TULSA METROPOLITAN AREA PLANNING COMMISSION

For Meeting No. 2497

November 7, 2007

PUD 364-A: Detail Site Plan – Northeast corner of 101st Street and Mingo Road; CS.

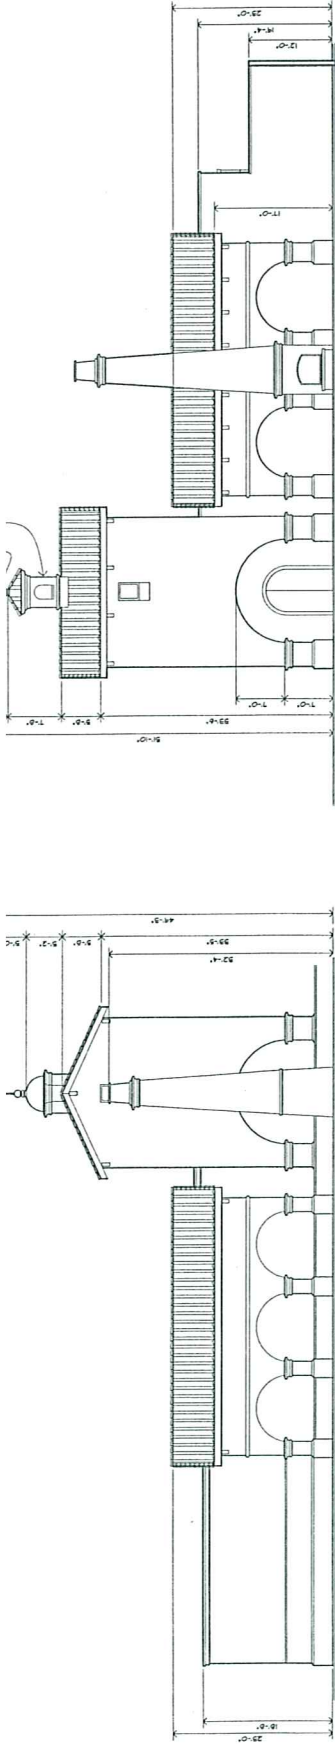
The only condition in addition to those proposed and reflected on the site plan is that the 6 foot screening fence be of masonry materials rather than the proposed wood screening fence. This conditions is imposed when the adjacent and abutting properties are single-family residential. This requirement can be reflected on the landscape plan when submitted for approval.

Therefore, staff recommends **APPROVAL** of the detail site plan for PUD-364-A as submitted subject to the masonry screening fence.

CLAREHOUSE
SHEET 1 OF 1

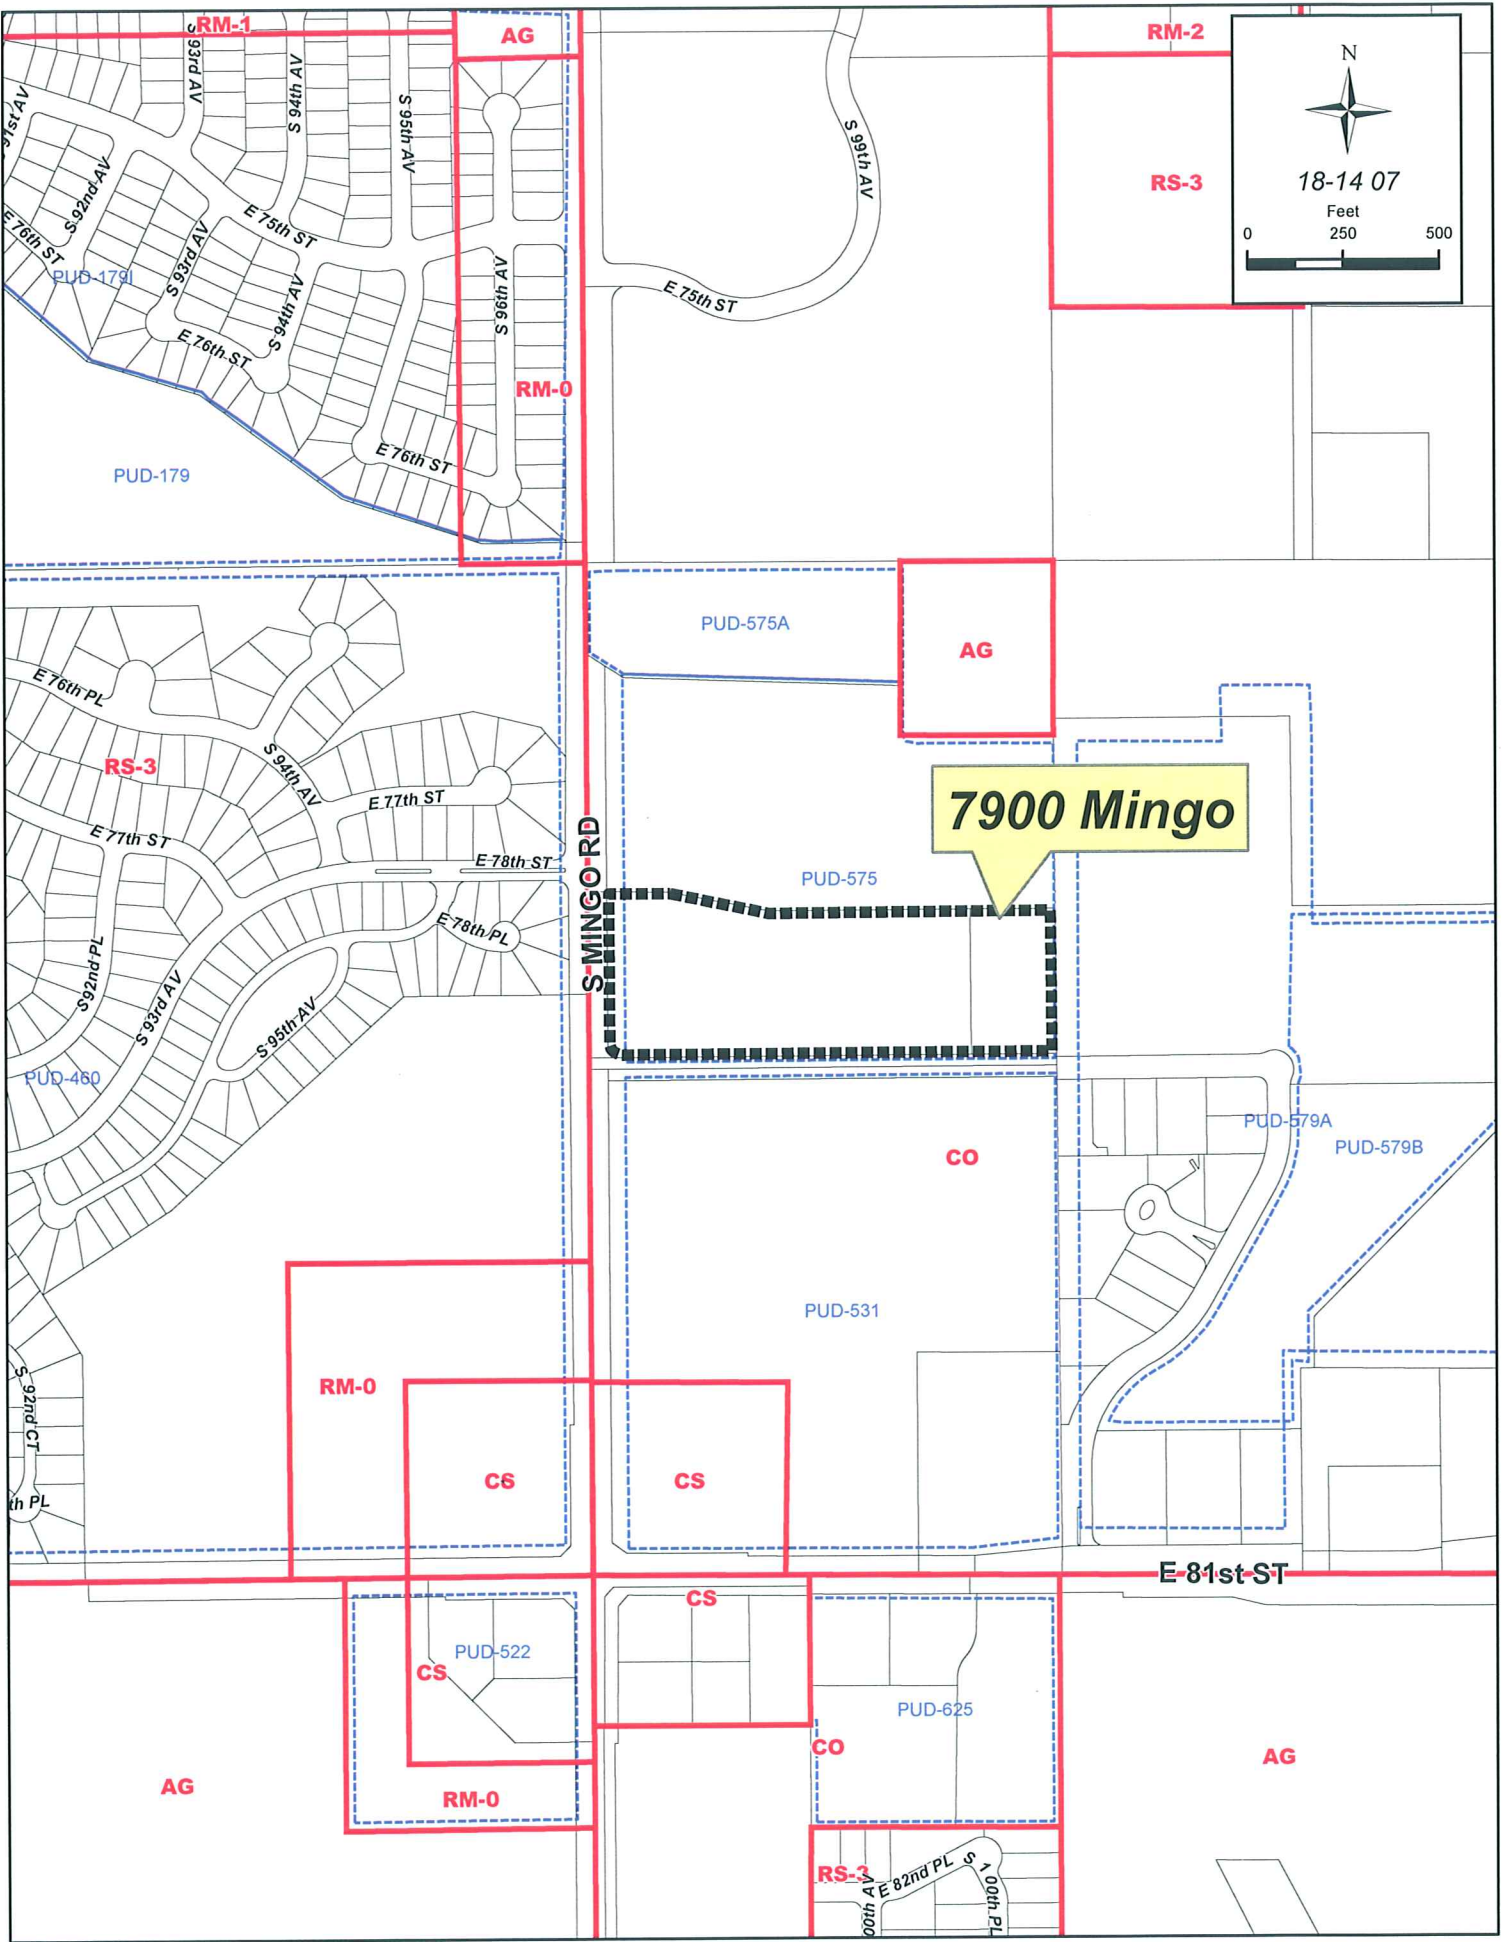
1. **Zoning:** The property is zoned CO/PUD 575, SP Z6611-SP-1. Plat must meet all CO/PUD requirements and have these reflected in the covenants.
2. **Streets:** Show existing right-of-way. Sidewalk required along Mingo. Document all adjacent right-of-way. Provide for a mutual access easement for Estancia to/from 79 East Avenue as its principal access. Include standard language in the covenants for mutual access easements.

3. **Sewer:** Add a minimum 15 foot wide sanitary sewer easement along the common boundary for Lots 3 and 5, and for Lots 4 and 6. Add language for the sanitary sewer easement to the covenants. The proposed sewer main extension to the south must begin as low as possible, and be designed at minimum grade so it can be extended to serve the area to the south of this development. Excess capacity fees of minimum grade so it can be extended to serve the area to the south of this development. Excess capacity fees of \$1,128.03/acre, and Broken Arrow System Development Fees of \$700.00/acre will be required.

4. **Water:** Show a 15 foot restricted water line easement for all proposed water main lines on-site. A water main line extension will be needed to provide water services and hydrant coverage.

5. **Storm Drainage:** Add and label the boundary of the "West Branch Haikey Creek City of Tulsa Regulatory Floodplain" that crosses Lot 1 and possibly 2. Add the overland drainage easement in the reserve for this floodplain, which will contain the floodplain plus 20 feet for access. Add a legend to show all unlabeled lines, abbreviations, and symbols. Add storm sewer easements to the face of plat. Add a subsection for overland drainage easement in reserve to Section I, for the floodplain. If the floodplain is being changed, then both existing and proposed floodplains must be shown and labeled. Show the conceptual design for the new conveyance system, which removes Lots 1 and 2 from the floodplain.

PRELIMINARY SUBDIVISION PLAT

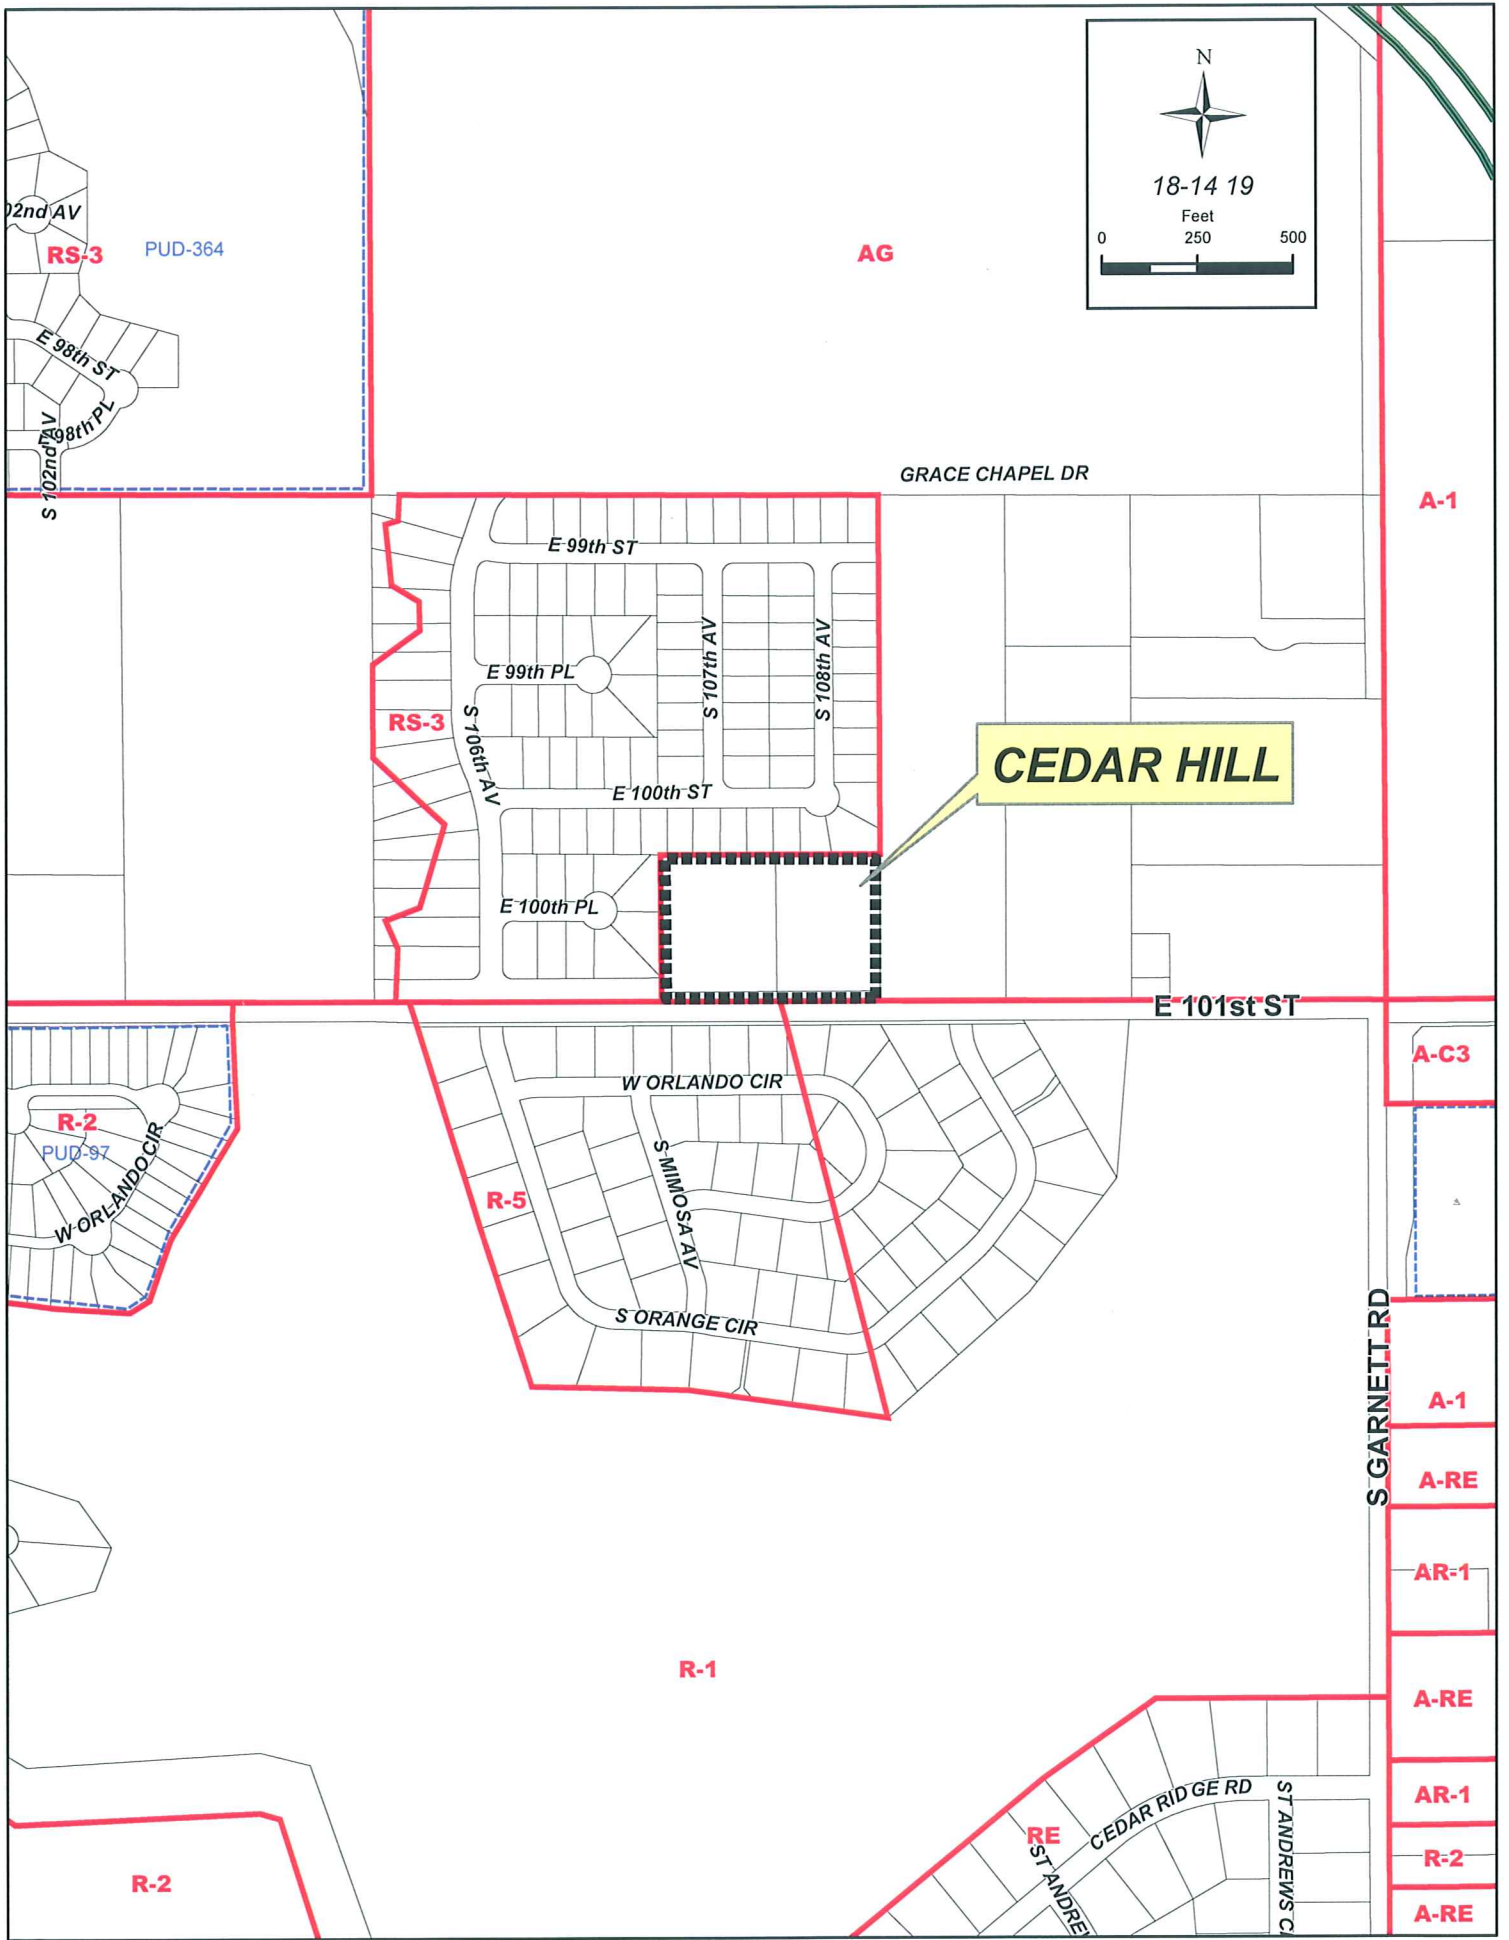
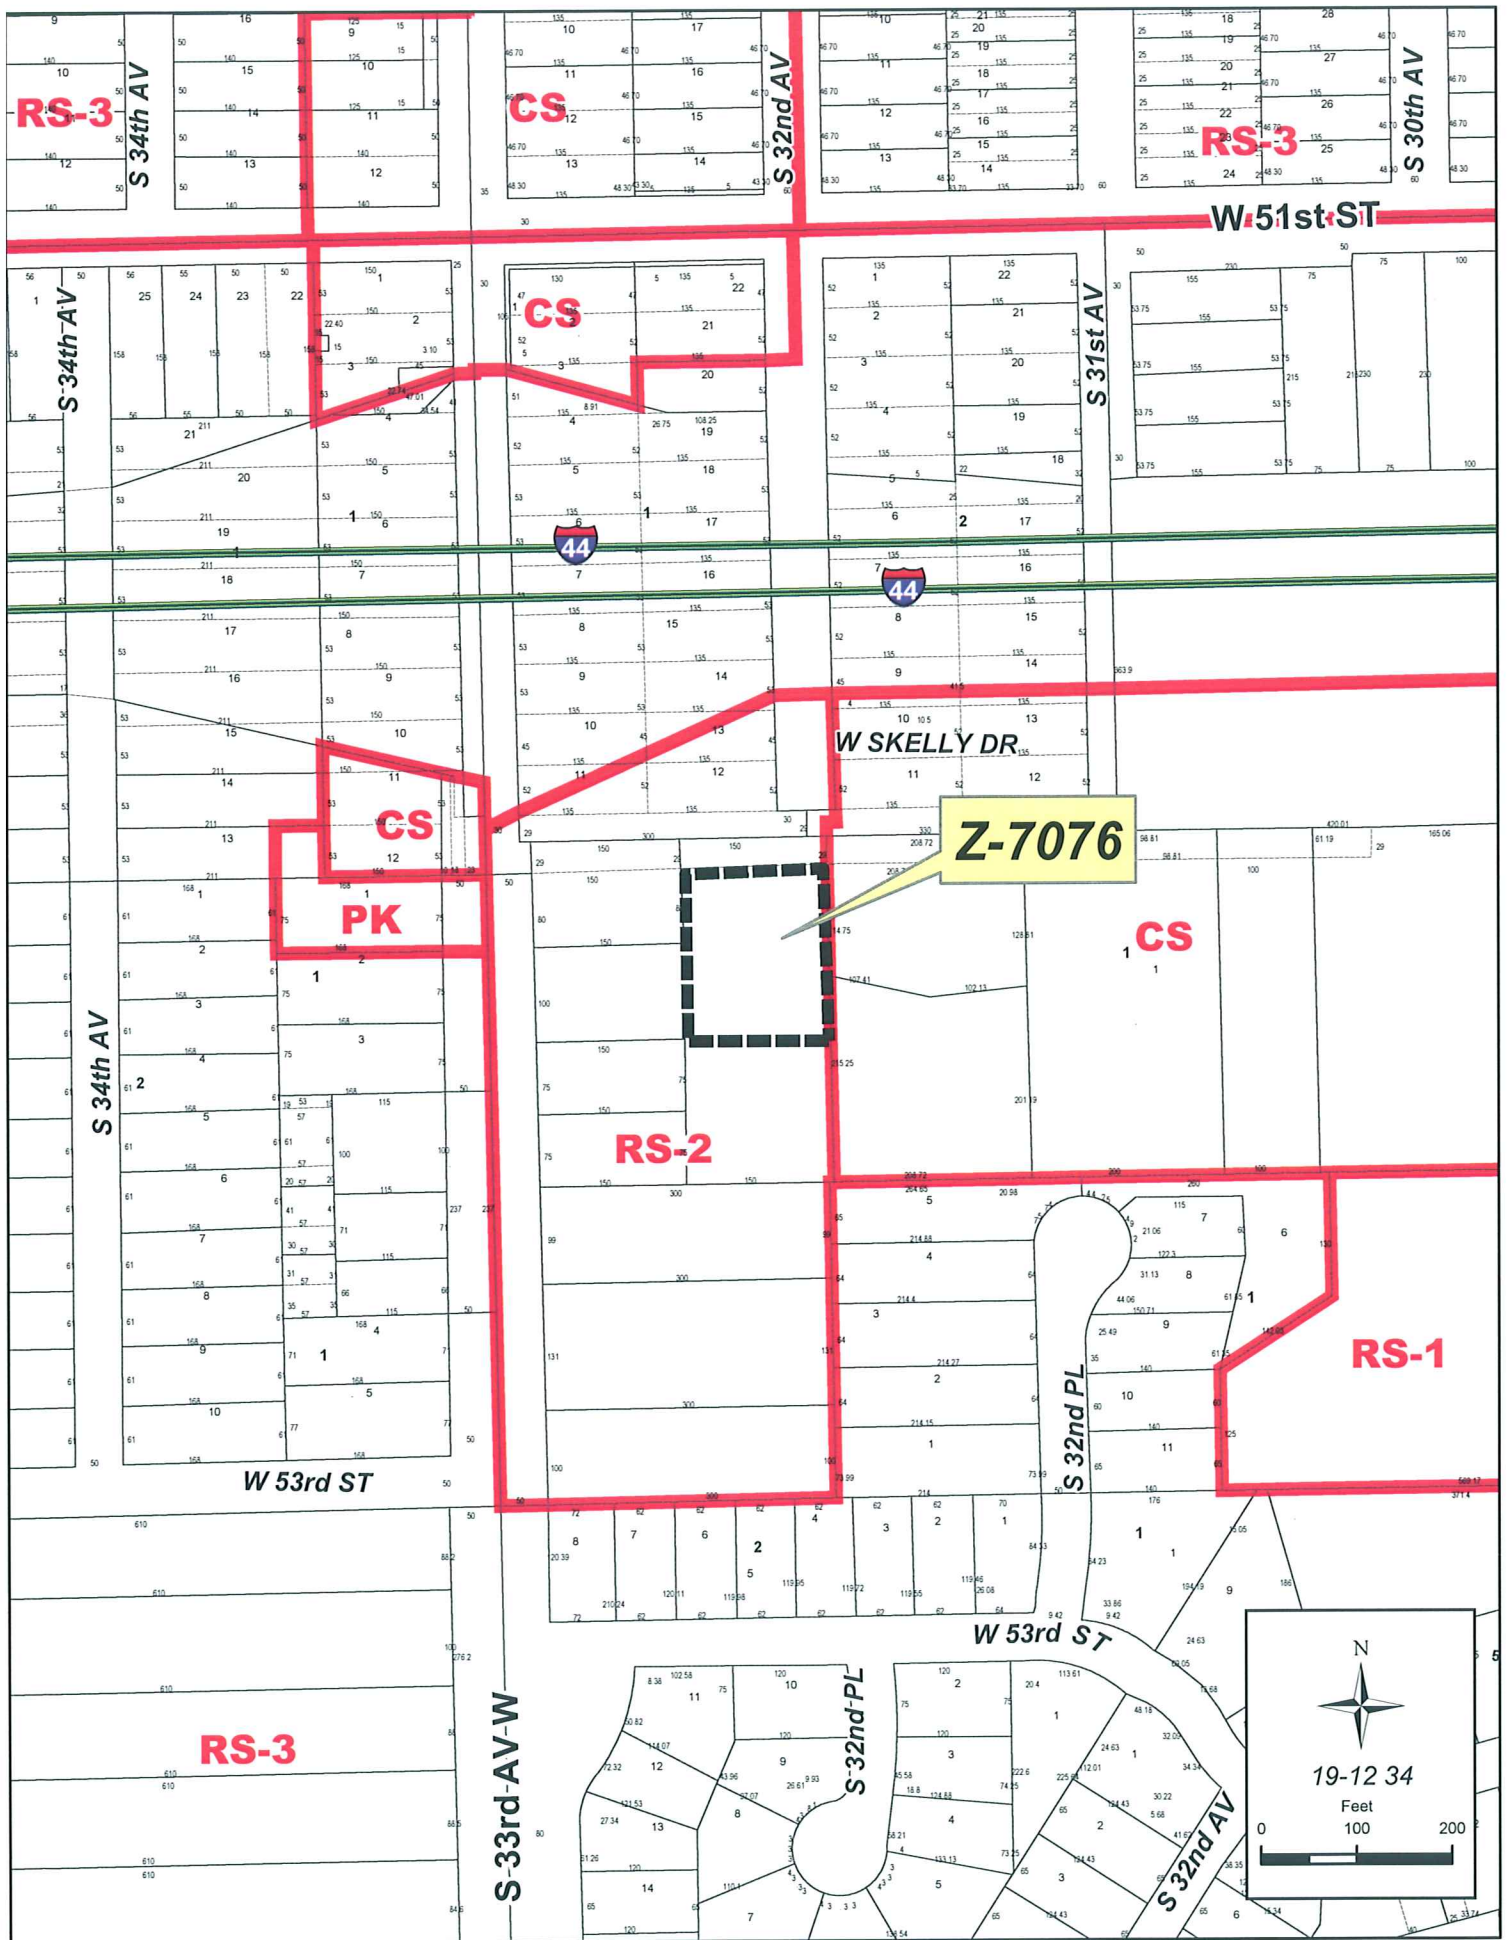
1. **Zoning:** The property is zoned PUD 741 (RS-2). Show public versus private streets. Show Development Areas. Sidewalks required per Subdivision Regulations and PUD. A homeowners' association must be formed for maintenance. Show lot square footages. All PUD conditions must be met.

2. **Streets:** Sidewalks will be required. Change the access to read "access w/median". Increase the Joplin Transition from 3:1 to 15:1 at the entry. Show sidewalk easements. Show the island with all dimensions as a Reserve at the Joplin entry. In Section IA include standard language to dedicate the street right-of-way. In Section IV.A please specify the maintenance of the private street. Recommend providing for two exit lanes and striping the center approach to the island.

3. **Sewer:** All perimeter easements adjacent to unplatted property must have either a 17.5 foot easement instead of the 11 foot easement shown, or provide an 11 foot easement by separate instrument along the unplatted property. This will result in a total of 22 feet for utilities. Continue the 11 foot easement along the east boundary of the plat through Reserve B. The back lot easements for the lots adjacent to Reserve B must be increased to 17.5 feet or a minimum of 11 foot additional easement added to Reserve B. The north easement in Lots 9 and 10, Block 7 must be a minimum of 15 feet in width. Lots 1-4, Block 3 and Lot 16, Block 2, do not have access to sanitary sewer service. Extend one of the sewer lines within Lots 5 and 6, Block 7 to serve Lot 8, Block 5, Forest Park South. The north arrow points west. Maintain adequate depth of the sanitary sewer line in Block 7 to allow for a mainline extension to serve Forest Park South.

4. **Water:** Add restricted water line easement language. A water main line extension will be needed to provide water services and hydrant coverage. Water main lines must be installed around the cul-de-sacs in Block 2, Lots 6-8 and Block 5, Lots 14-17.

5. **Storm Drainage:** Reserve B must be labeled as a stormwater detention facility. Add an access easement to the plat to access the bottom of the

stormwater detention facility from one of the adjacent streets. The covenants have an overland drainage easement (ODE) section. The ODE's must be shown and labeled on the face of plat. Lot 15, Block 7 is shown by contours on the conceptual plan to contain major overland drainage. Is this where the ODE should be? The conceptual plan also shows a large area that is not a part of this plat, however, storm sewers extend from this plat to a stormwater detention facility in this off-site area. Add a note to the face of plat that states, stormwater detention for blocks 1-4 has been provided off-site, in an area located approximately 900 feet east of the centerline of South Joplin Avenue and immediately north of East 111th Street South. A stormwater detention easement will be provided by separate instrument for the off-site facility. No construction will be allowed in blocks 1-4 until this facility has been constructed. Show and label this area on the location map. Add the standard language for Reserve B, stormwater detention facility maintenance. Place the ODE in a Reserve and modify the language in Section IJ to be the standard language for this type of ODE. Add a roof drainage subsection to Section I to state that all roof drains will be conveyed to the public drainage system or the stormwater detention facilities, whichever your intended design calls for. Show and label the ODE and the stormwater detention facilities and include them in your legend.
